Prairie Island Nuclear Generating Plant
License Amendment Request Dated January 13, 1986

Evaluation of Proposed Changes to the
Technical Specifications Appendix A of
Operating License DPR-42 and DPR-60

Proposed Changes Marked Up
on Existing Technical Specification Pages

SAFETY LIMITS, REACTOR CORE,
THERMAL AND HYDRAULIC
TWO-LOOP OPERATION
FIGURE TS.2.1-1

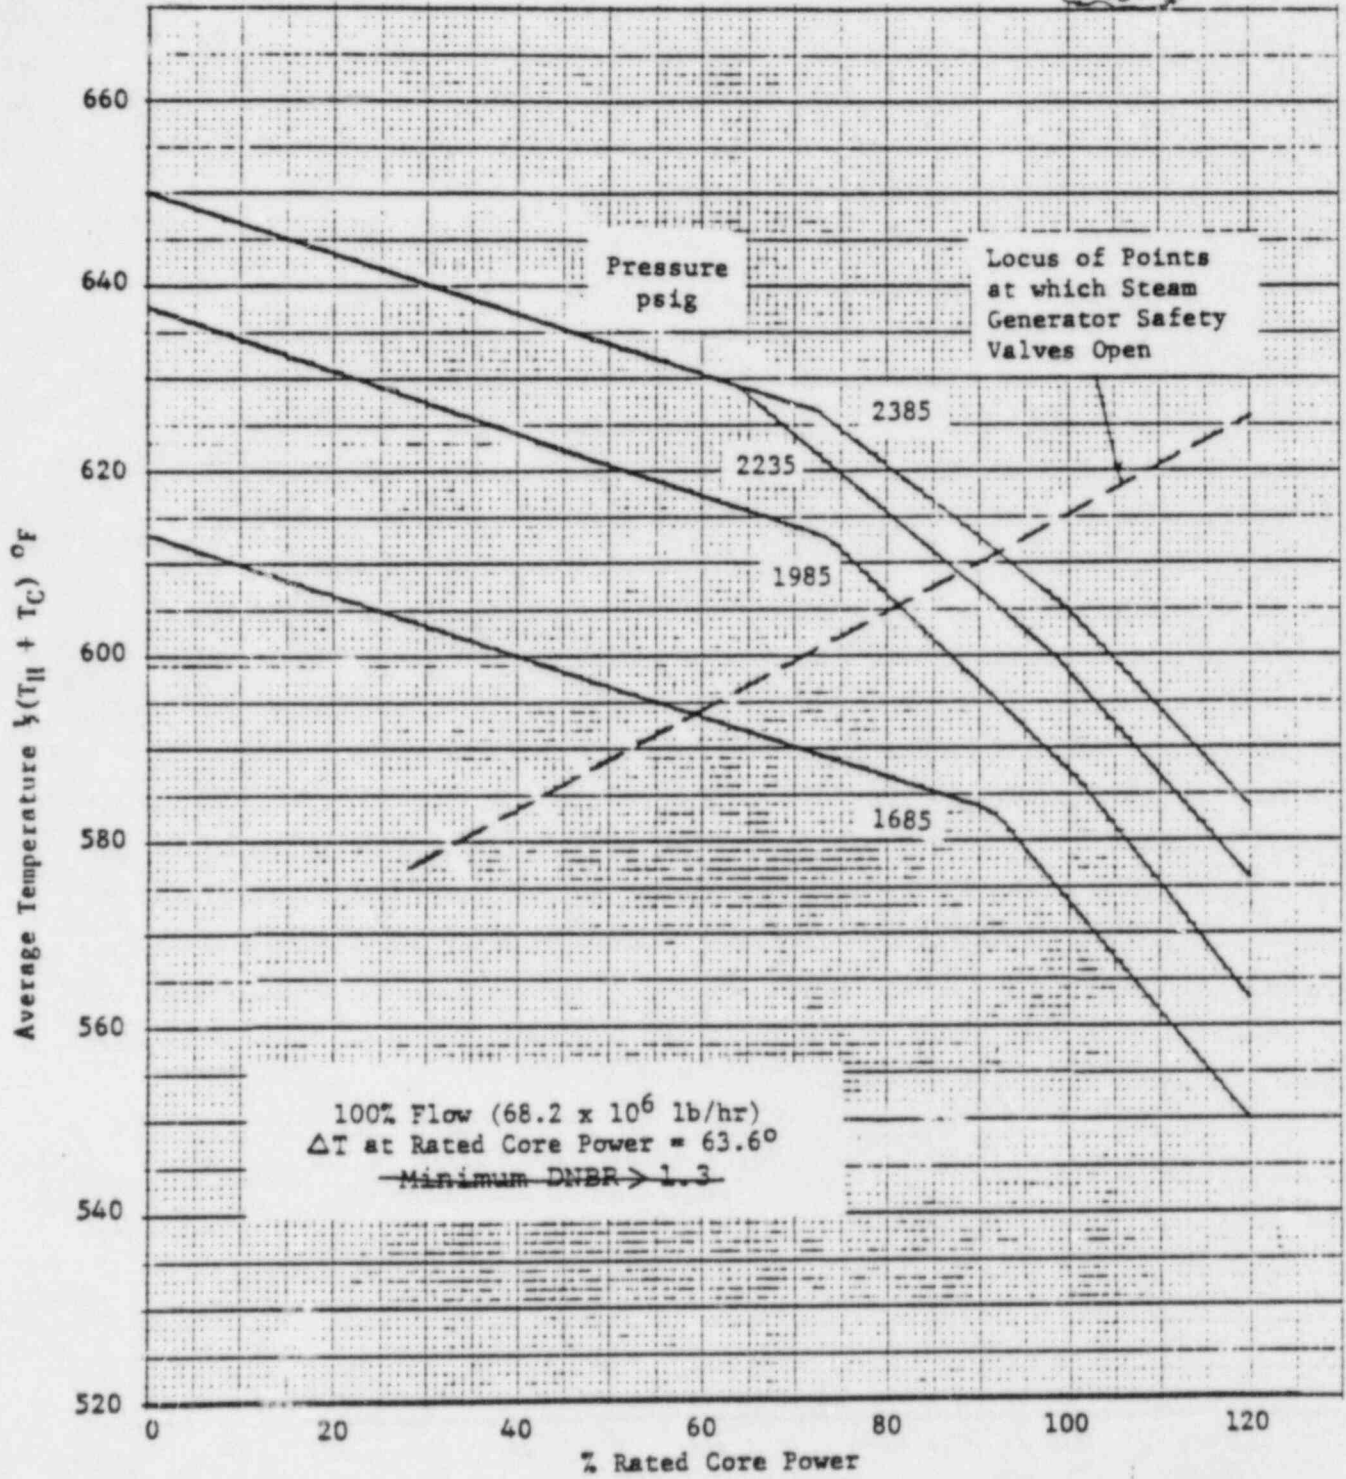
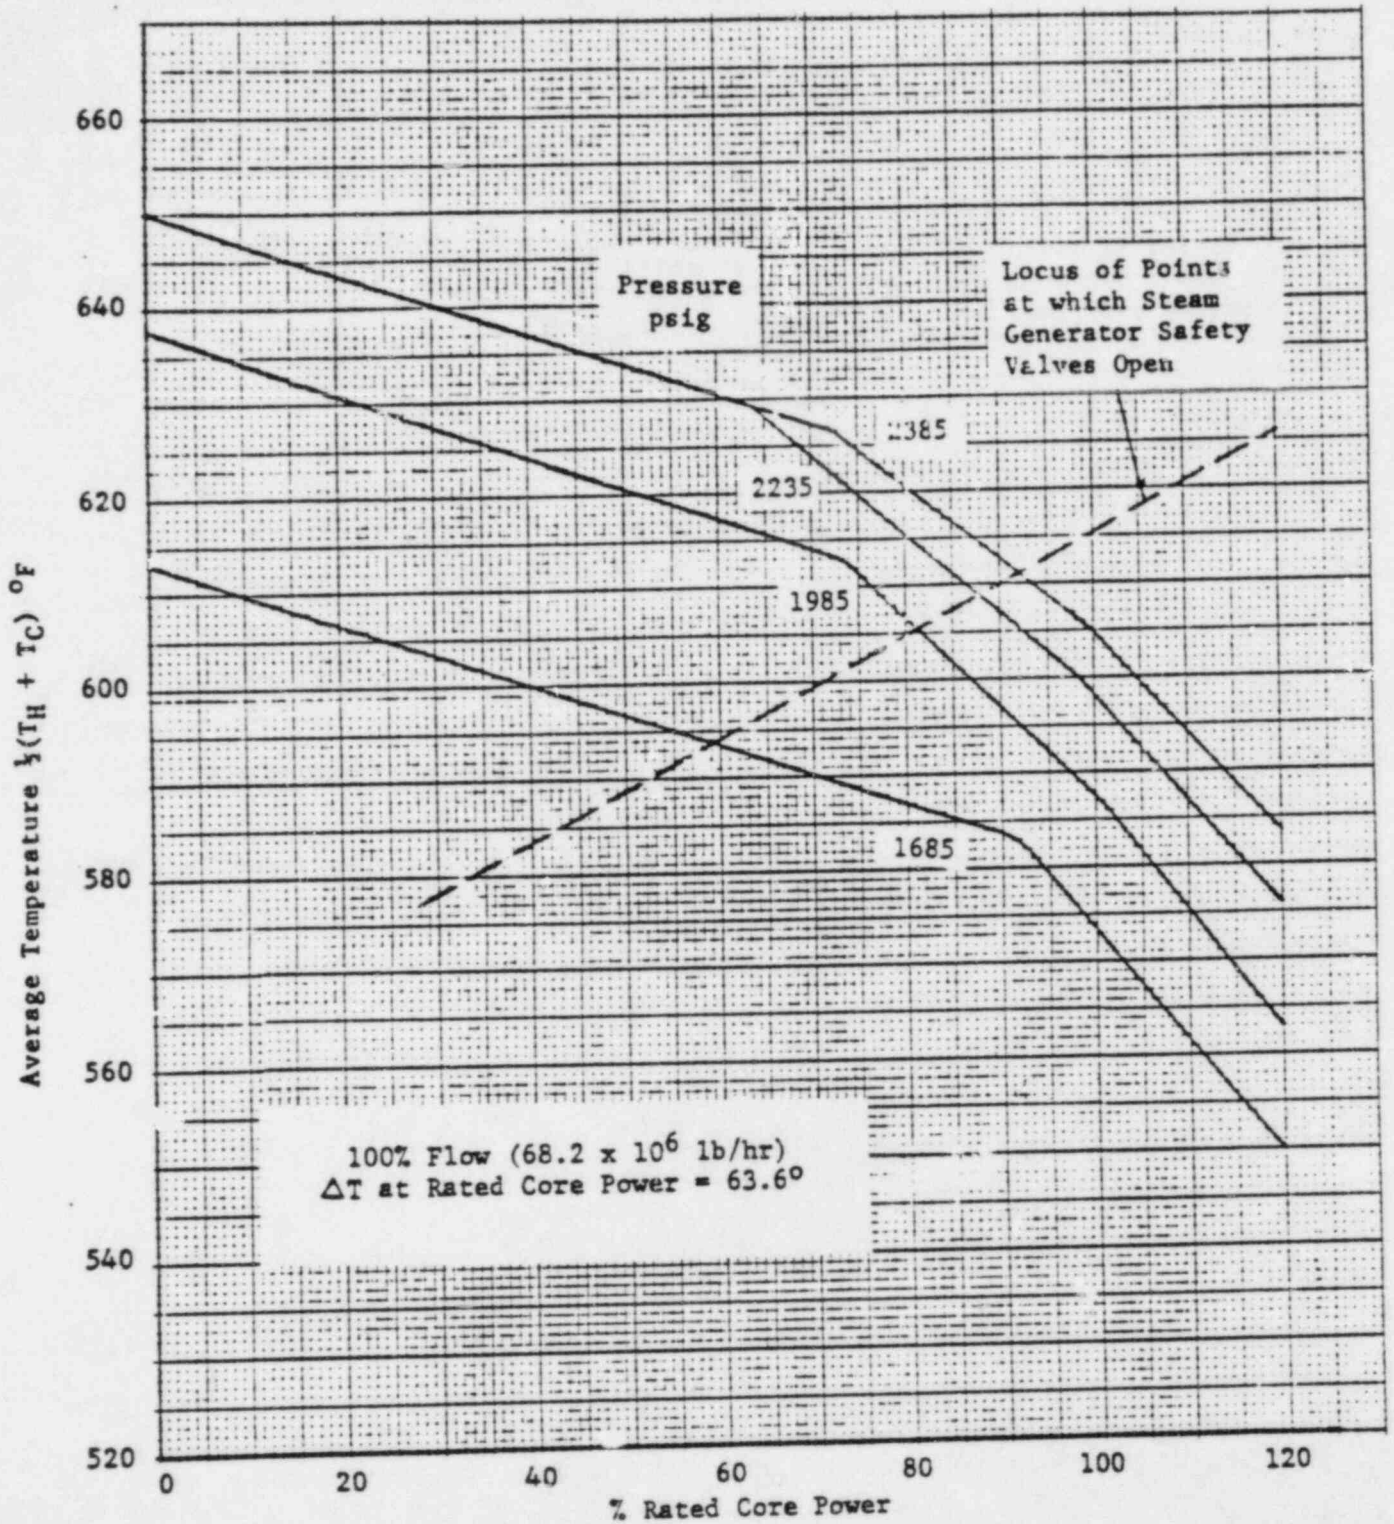
Add reference to the WRB-1 DNB correlation for Westinghouse fuel and identify that the W-3 DNB correlation will be used for Exxon fuel.

Pages affected: TS.2.1-1, 2, 3, TS.2.3-6, TS.3.10-8, TS.3.10-13, Figure TS.2.1-1 (The bases on existing page TS.2.1-3 will be moved to proposed page TS.2.1-2. Therefore, there is no page TS.2.1-3 in Exhibit C.)

FIGURE TS.3.10-5
REV 66 ~~10/3/83~~

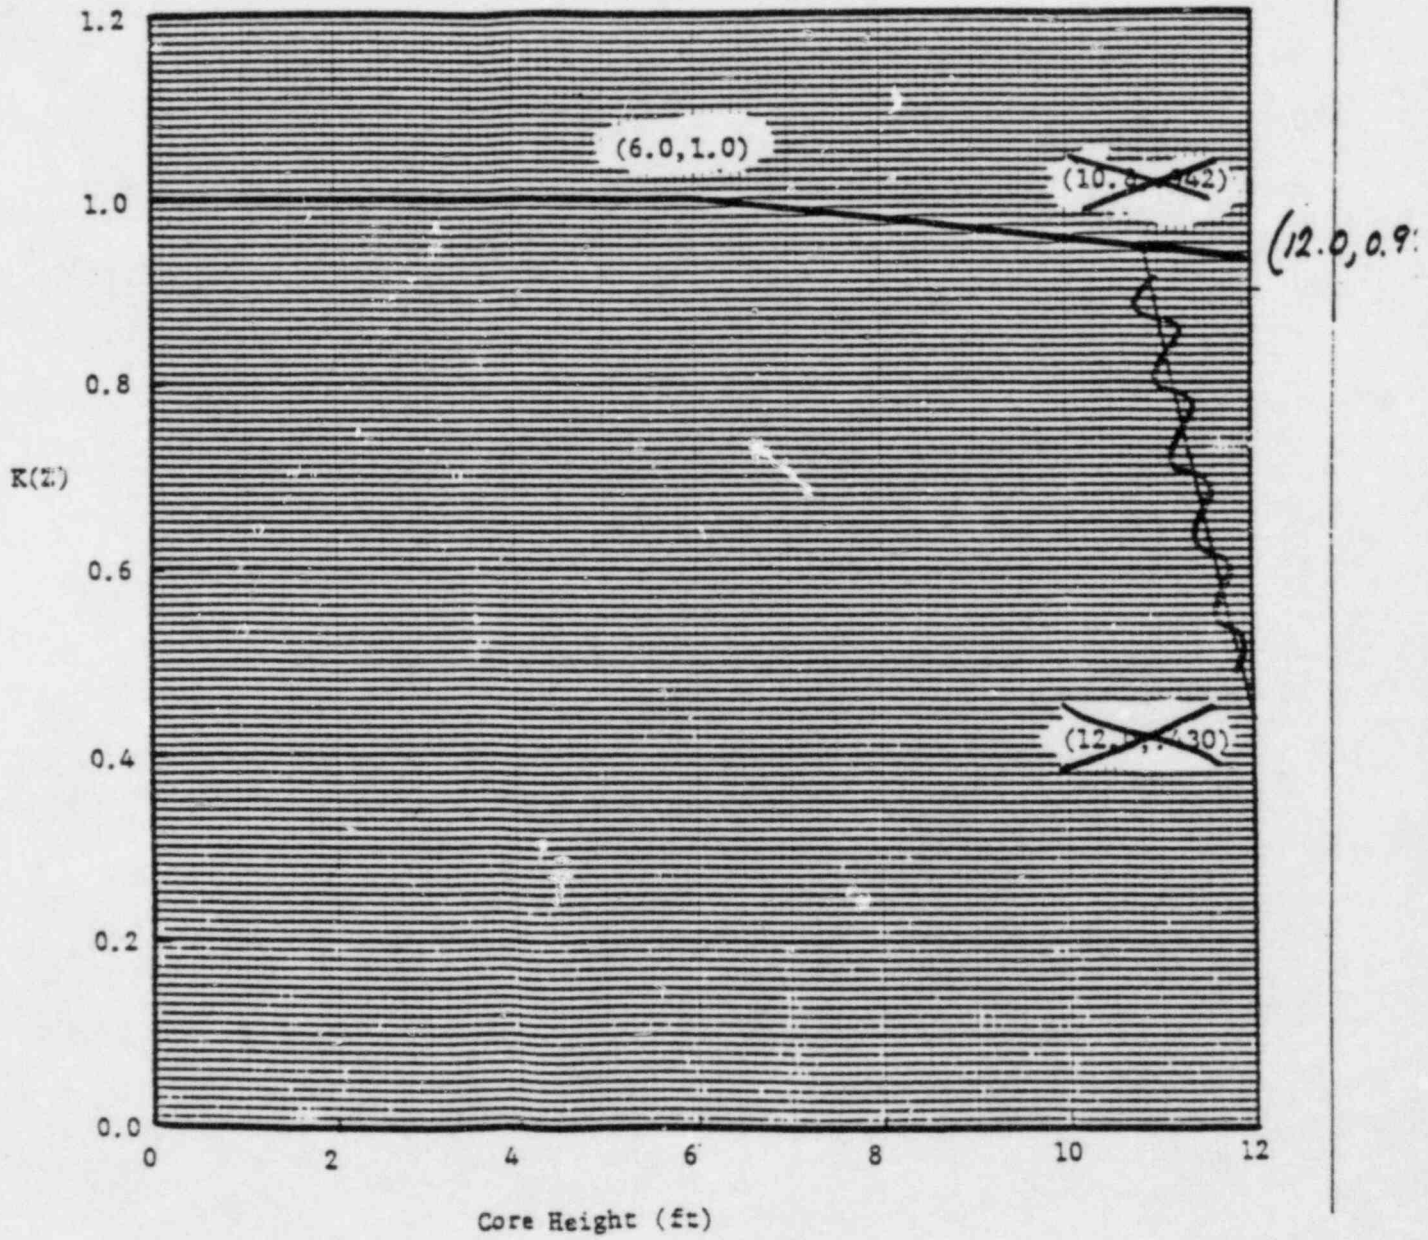
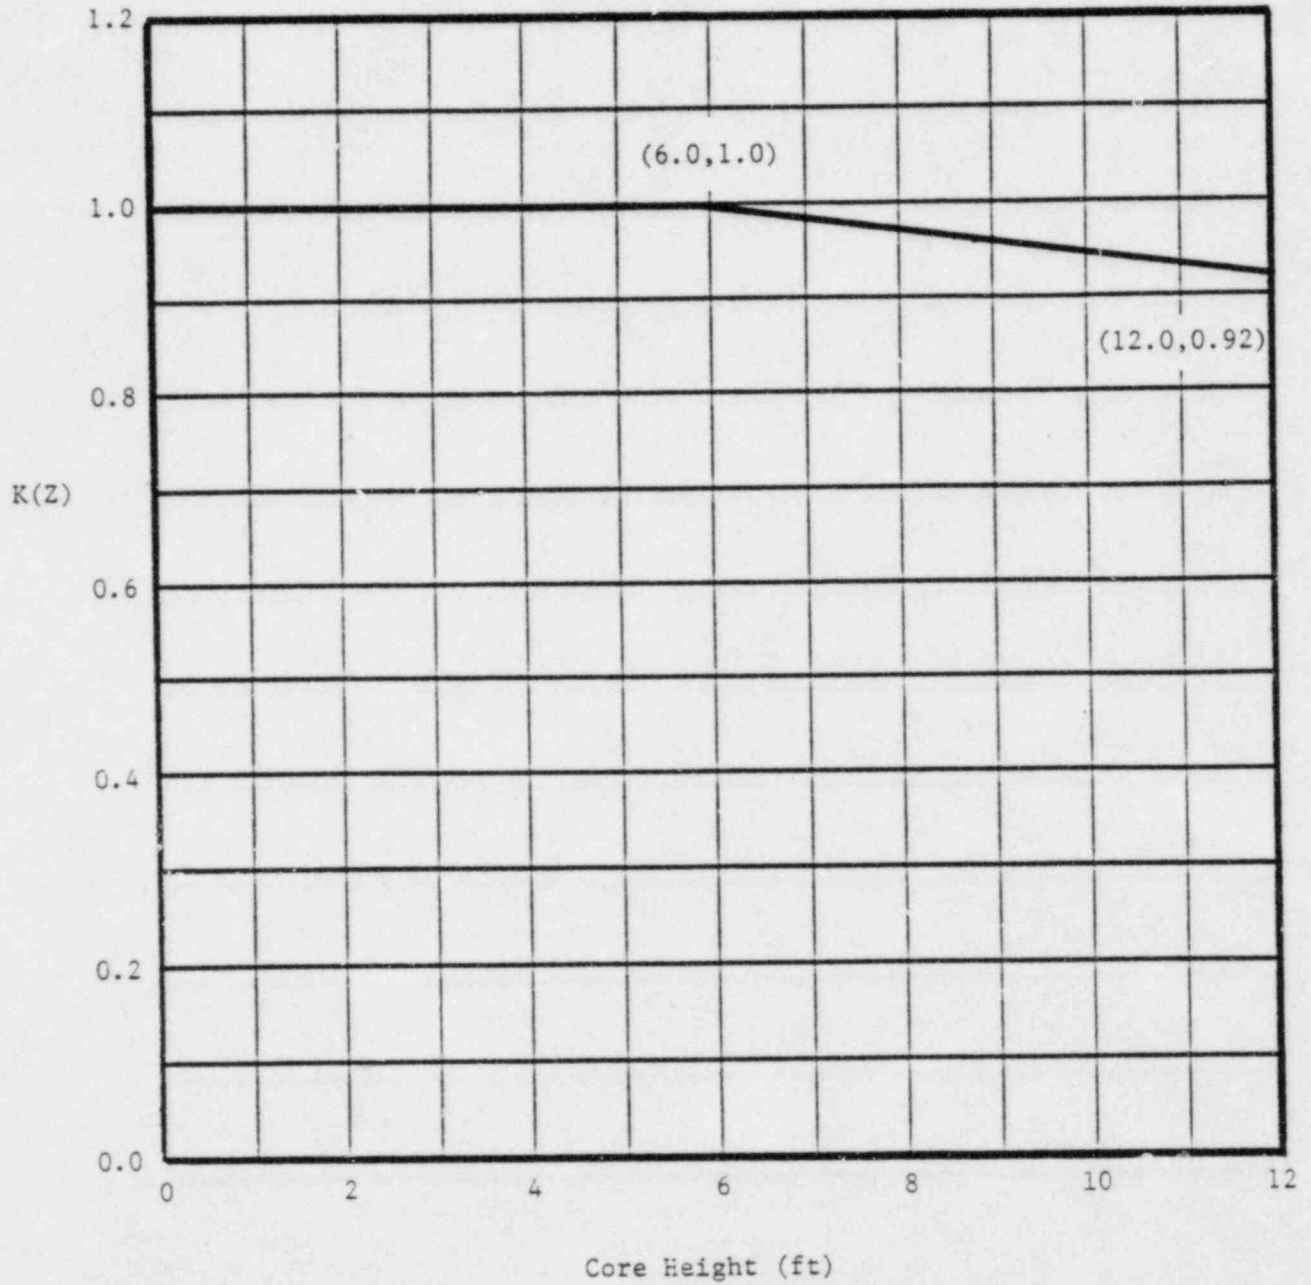
On Figure TS.3.10-5, delete the third line segment and extend the second line segment to the 12 foot level.

Change the associated Bases.

Pages affected: TS.3.10-9, Figure TS.3.10-5

This change will allow more F_Q flexibility in the top of the core.

This change is supported by recent small break LOCA analyses performed by Westinghouse on Westinghouse and Exxon fuel assemblies. The Westinghouse fuel analysis is contained in Exhibit F and the Exxon fuel analysis is contained in Exhibit G. Both analyses show that the small break LOCA peak cladding temperature is approximately 1000°F and support the removal of the third line segment of the K(z) curve.

FIGURE TS.3.10-7
REV 67 12/28/83

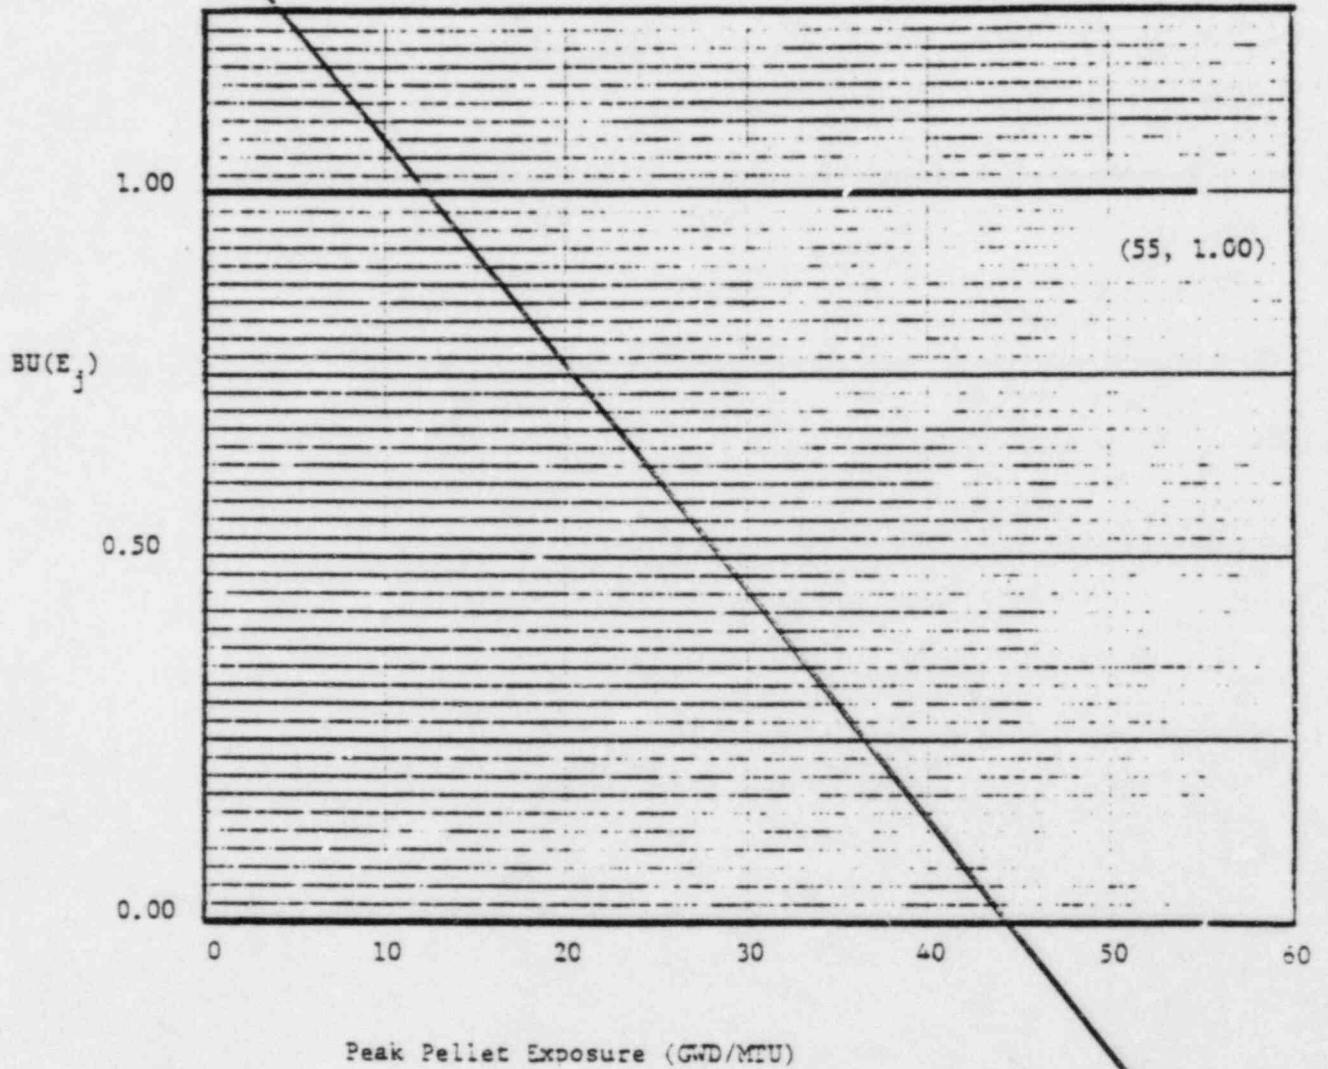
Delete Figure TS.3.10-7, renumber the next sequentially numbered curve and delete references to the curve.

DELETE

The normalized exposure dependent function, $BU(E_j)$ was used for Exxon Nuclear fuel. Since this value of this function is one for all burnup values up to 55 GWD/MTU, it can be deleted.
